# **Responses for reviews of "The Orbiting Carbon Observatory (OCO-2): Spectrometer performance evaluation using pre-launch direct sun measurements"**

Reviewer comments in black italic, responses in red

# Rev. #1:

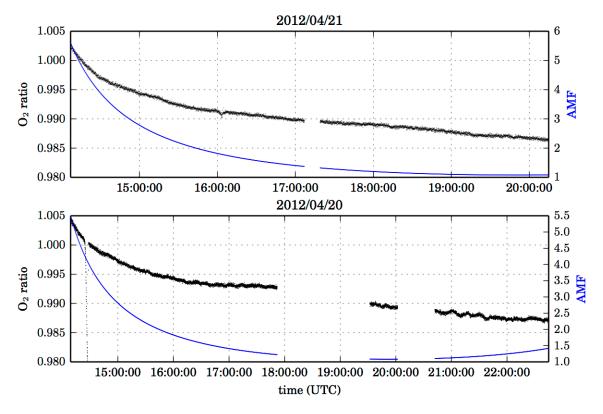
2. The MATADOR test is not very convincing with respect to its initial goal of quantifying (non-) linearity. If taken at face value, the 2-3 ppm differences for smaller signal levels in Figure 8 could be of concern, but then, the test seems inconclusive due to changes in the optical imaging. The latter might be of concern by itself (see comment above).

Would it be possible to strengthen the case? It might be helpful relating to lab-based nonlinearity testing, showing ratios of spectra with strong and weak illumination, comparing weakly and strongly absorbing bands (which should be affected differently by nonlinearity, in particular if non-linearity is most severe for low count rates)?

This is a very good point. We initially prepared ratio spectra figures already but omitted them so far as we already had a lot of figures. However, we also see the need for these and will include examples in the revised manuscript. It should be mentioned that this test was critical for the calibration of OCO-1, where the sphere set-up was not as good as for OCO-2 and led to large nonlinearities in the initial calibration, which were revealed by the matador tests (O'Dell et al., 2011). Because of the highly-improved integrating sphere set-up in OCO-2, the nonlinearities were almost non-existent, and the "ratio tests" merely validated this.
